**Gas cylinders — Non-refillable  
metallic gas cylinders — Specification  
and test methods**

**AMENDMENT 1**

Reference number  
ISO 11118:2015/Amd.1:2019(E)

Figure 1 — Weld joints

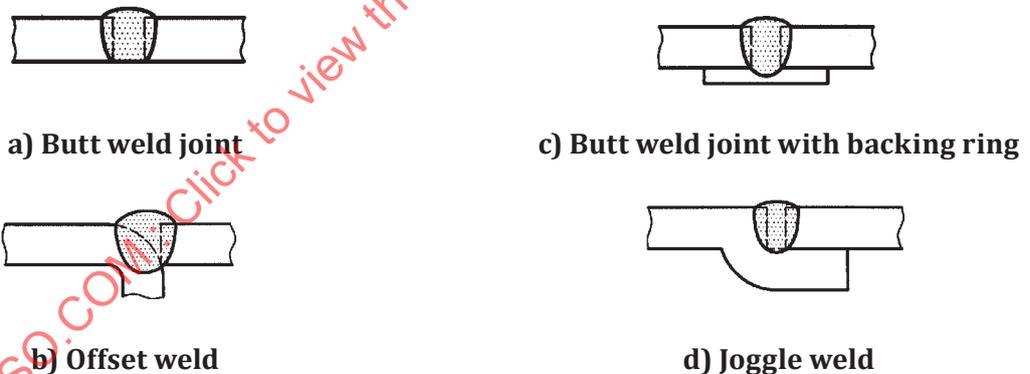
The circumferential seam(s), if any, shall be as illustrated in Figure 1 a), b), c) or d).

Replace Figure 1 with the following:
